Duquesne Light

Reference: Beaver Valley Power Station, Unit No. 1
Docket No. 50-334, License No. DPR-66
Generic Letter 83-28, Items 4.2.1 and 4.2.2

Response to Request for Additional
Information Regarding Salem ATWS Event
Items 4.2.1 and 4.2.2

Main Reactor Trip Breaker A

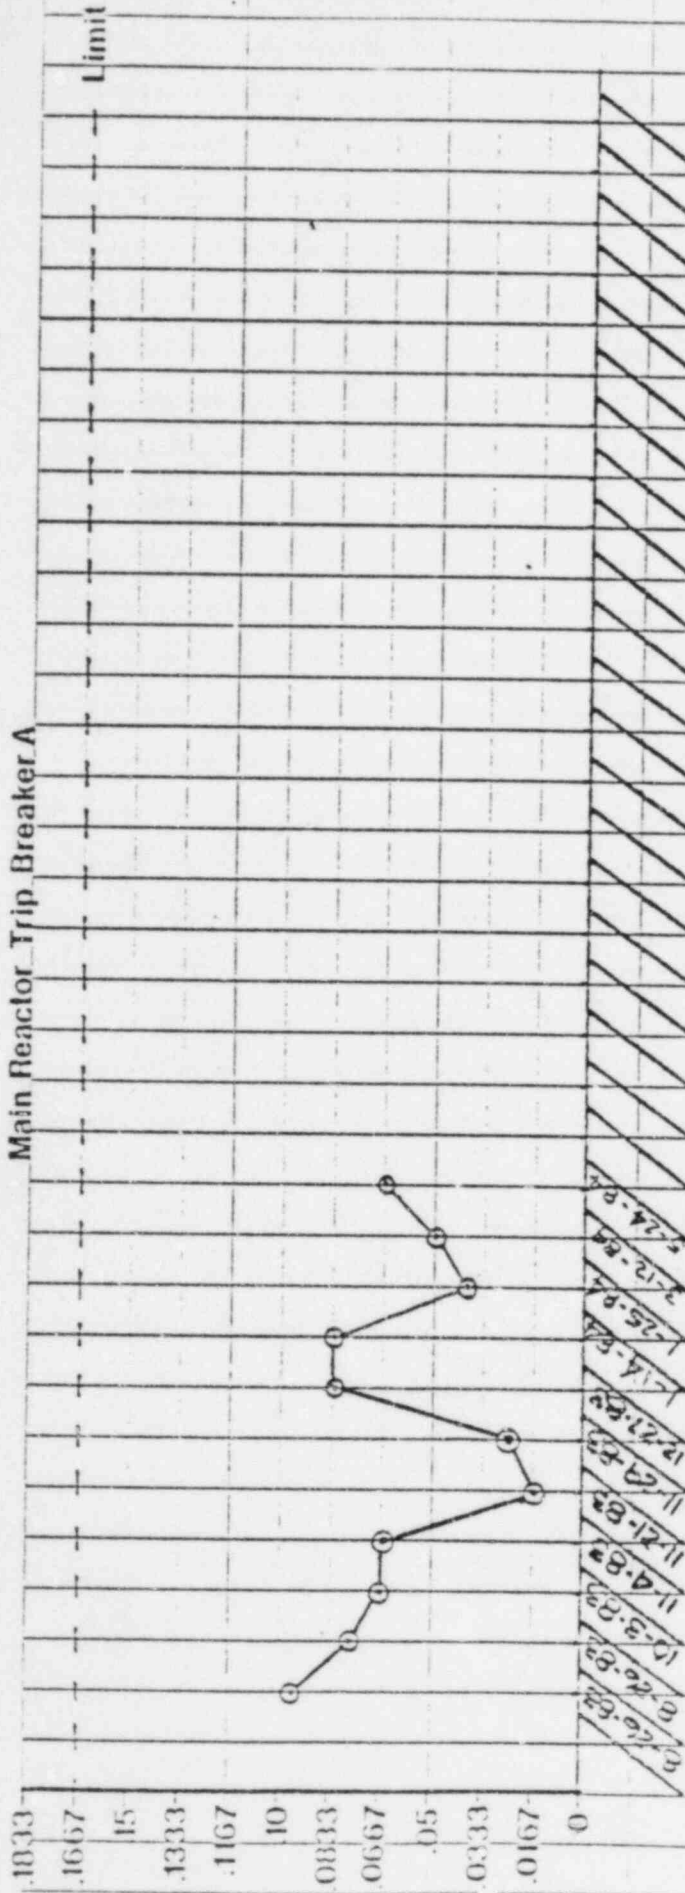
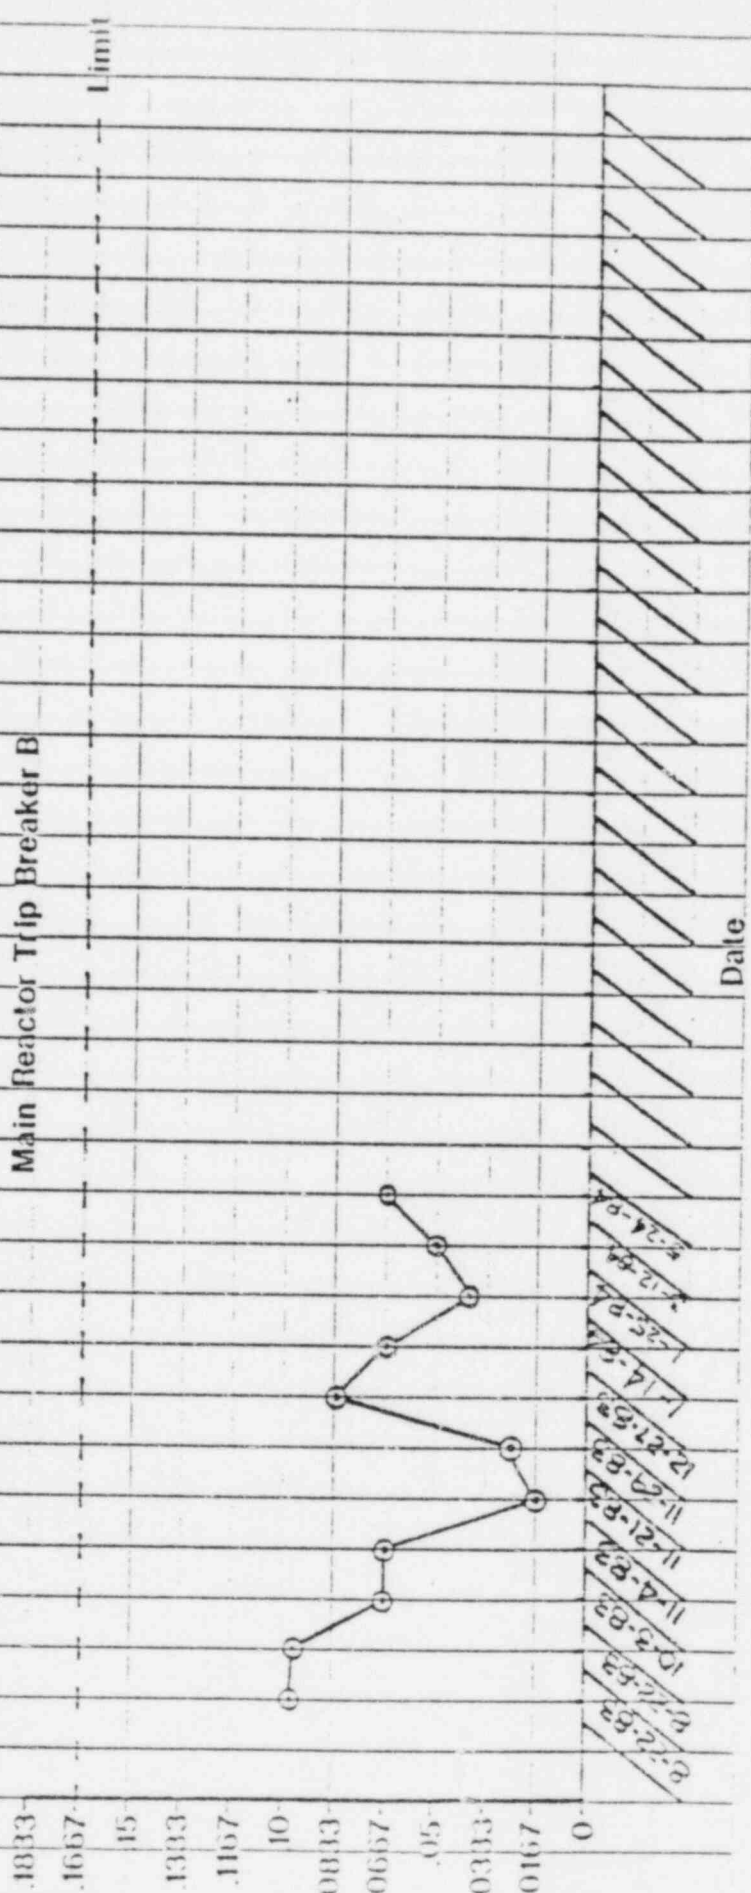
2.1 Information Request for Item 4.2.2

- The submittal states that trend report results of the reactor trip breakers will be issued periodically to the plant's upper management staff and significant degradation found during breaker trending will be immediately identified for corrective action. Please provide a discussion of the technical criteria to be used for evaluating trend data. It should include a description of the use of acceptance limits, establishment of baseline values or other basis for identifying significant degradation of the breaker. It should also indicate the schedule or guideline for scheduling evaluation of the trend data.

The technical criteria used to evaluate trend data are:

<u>Parameter</u>	<u>Criteria</u>
Time Response	≤0.167 seconds
UVTA Dropout Voltage	14.4 to 28.8 Volts
Trip Force	≤30 ounces
Insulation Resistance	≥2.0 megohms
Contact Pressure	0.050 to 0.093 inches
Contact Resistance	≤50 micro-ohms

These criteria are based on the WOG Maintenance Program, reviews of vendor information, and operating experience.

The data obtained from the various sources is compared to the acceptance criteria and plotted. If an unacceptable or questionable condition is identified, supervision is notified for a determination of appropriate corrective action. The parameters, except reactor trip times, have a tentative review schedule of 18 months, which is consistent with the frequency of the procedures which obtain the data. In addition to the trending review, all the procedure results are reviewed by a maintenance engineer upon completion.

The response time for reactor trips is reviewed on a monthly basis and reported to supervision in a monthly trend report. Attached is an example plot of trip breaker response time.
